# ADDENDUM #1

**Date:** August 8, 2019  
**City of Brookhaven RFP No.** RFQ 19-315  
**Project Name:** Briarwood Park Pool Project

**This addendum includes project clarifications, plan revisions due to permitting reviews, and responses to questions received by the Deadline for Questions (August 6, 2019 at 12:00 (noon) EST), .**

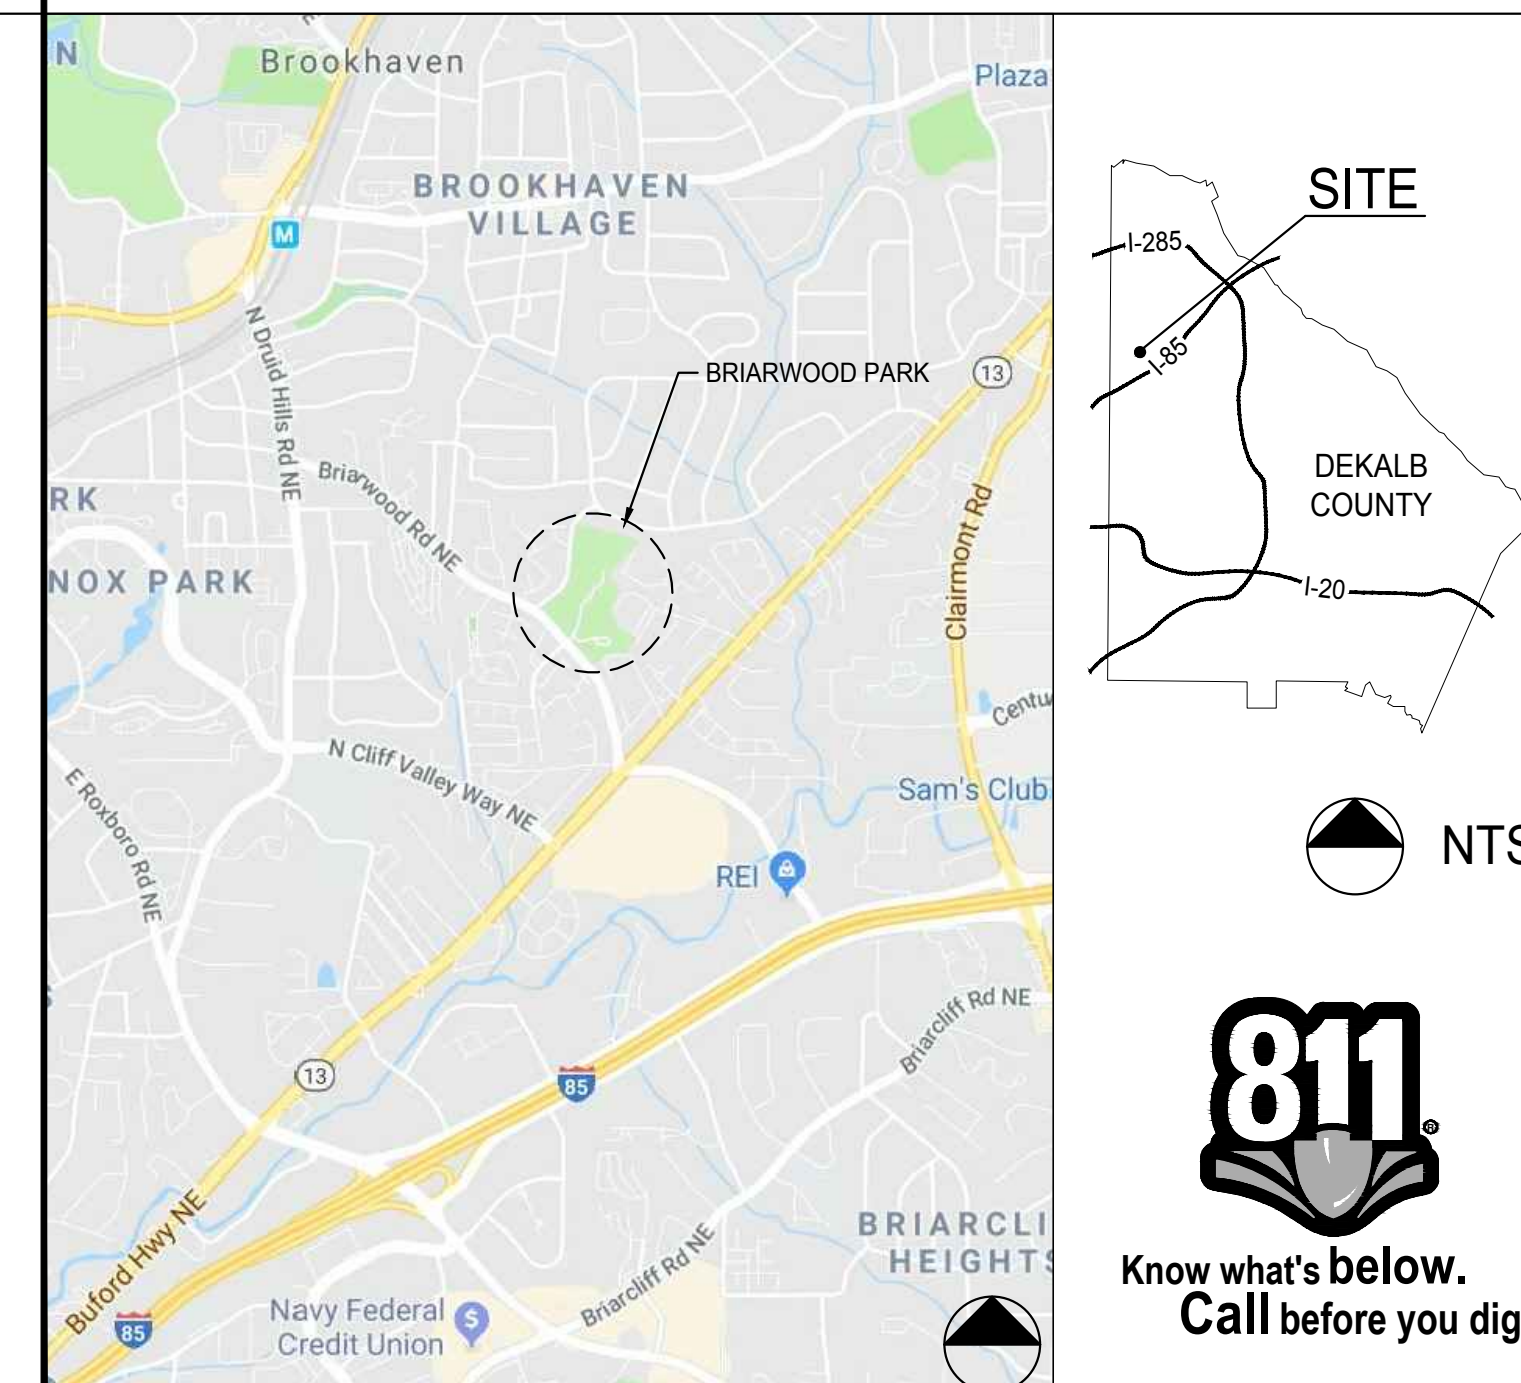
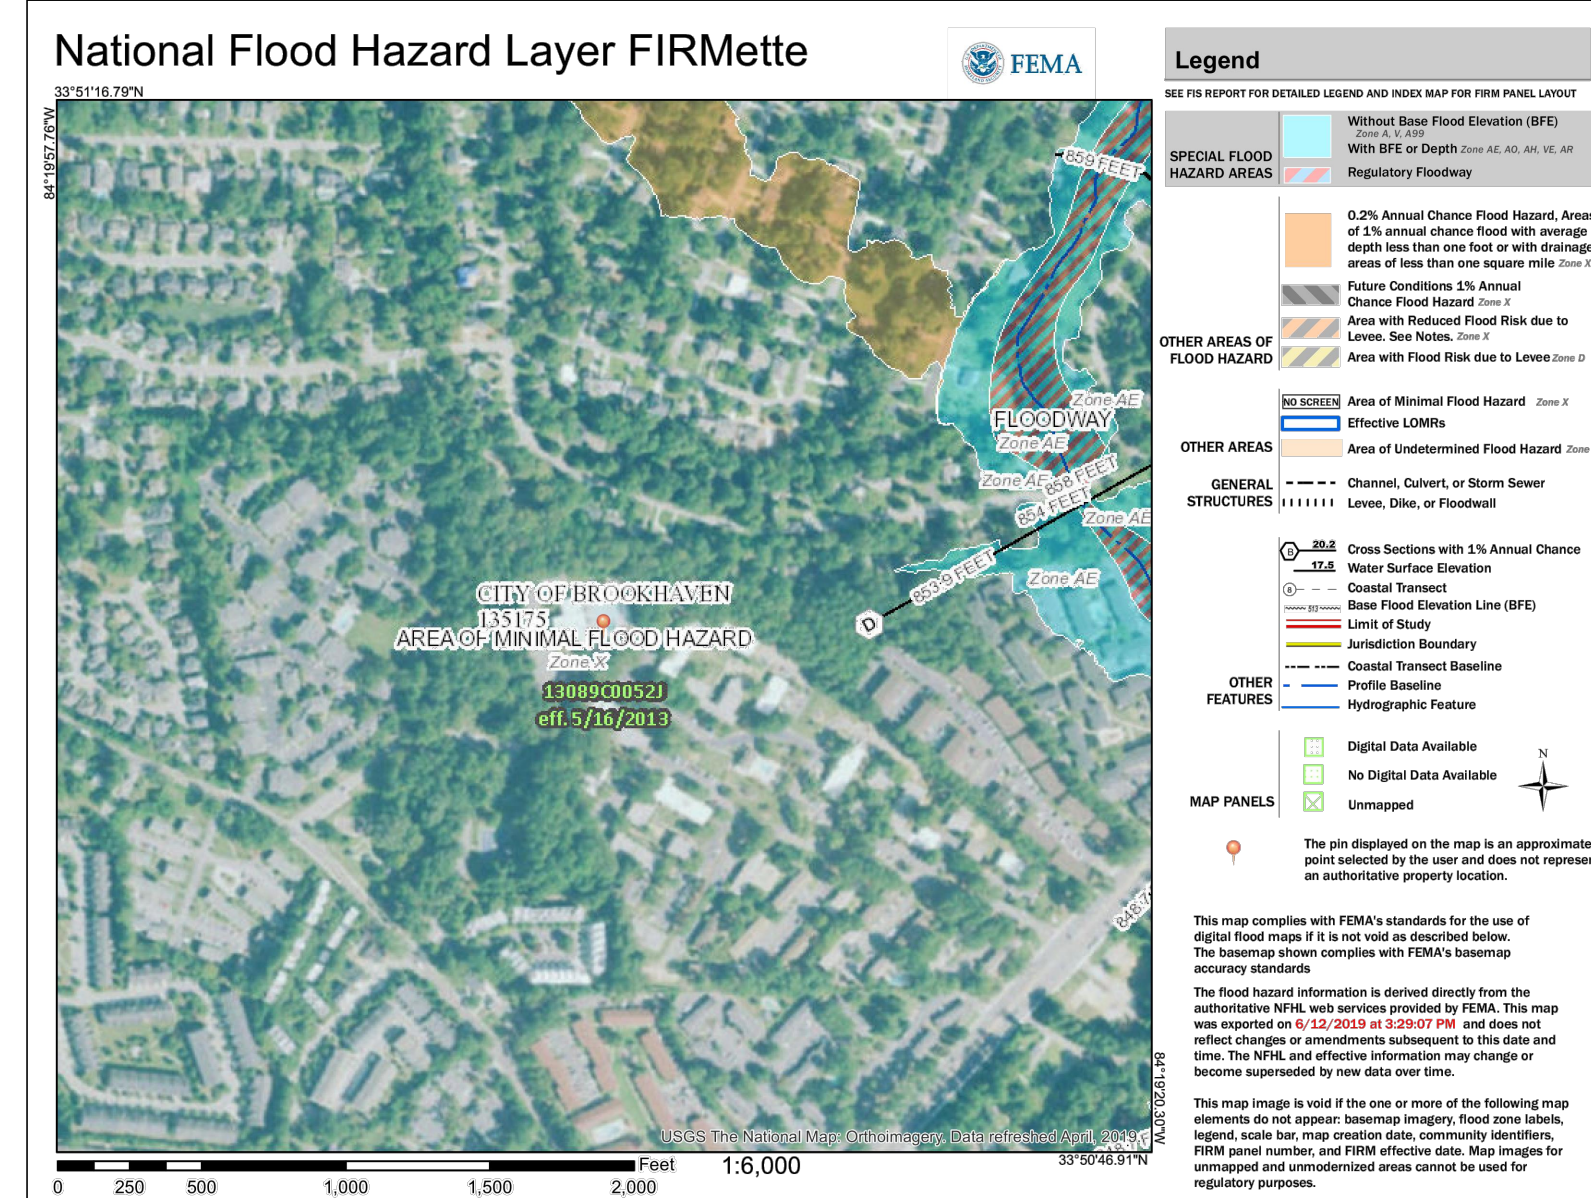
- a. C0.00 – COVER SHEET – *updated sheet index, added GPS coordinates for Construction Entrance, Revised owner's contact.*
  - b. C2.10 – ESPC PLAN SHEET KEY – *revised notes, added text for stream buffers*

PIPE CHART

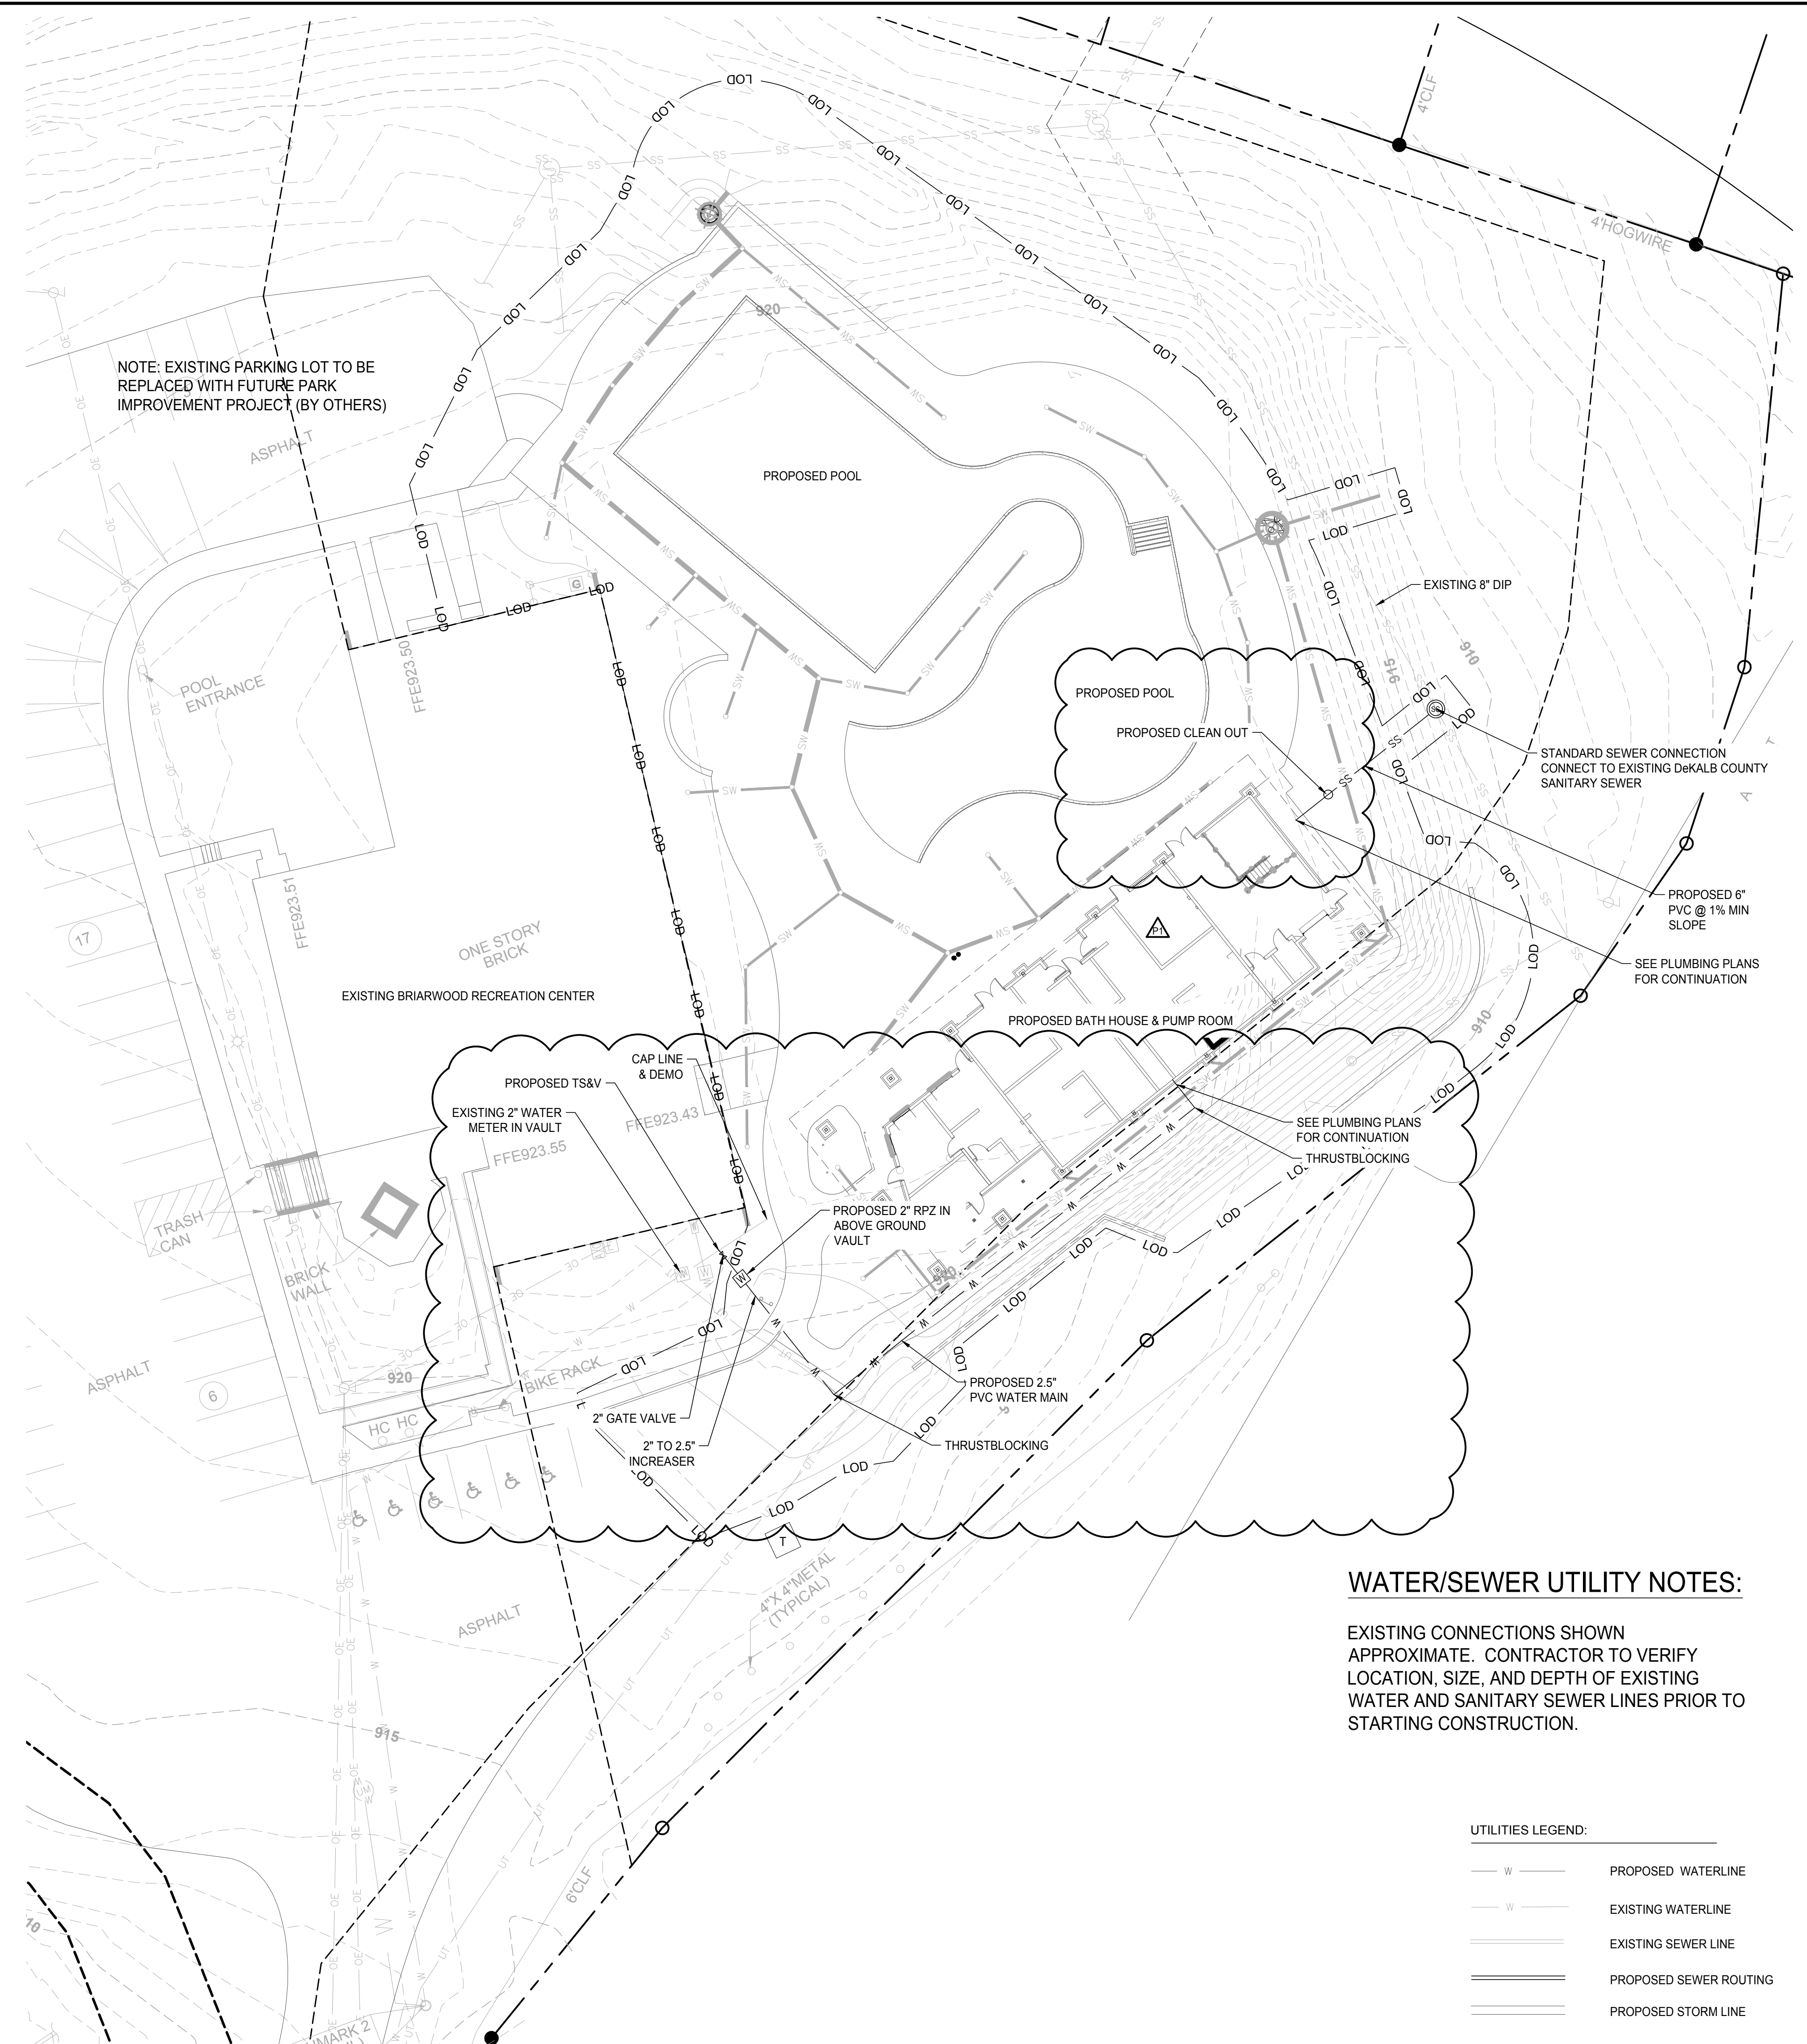
- m. C2.96 – PIPE CHARTS – *new pipe chart sheet*
  - n. C5.01 – UTILITY PLAN – *Added Clean Out, 1% Min. Slope on sanitary sewer service, and exterior RPZ on the water line between the meter and the building connection.*
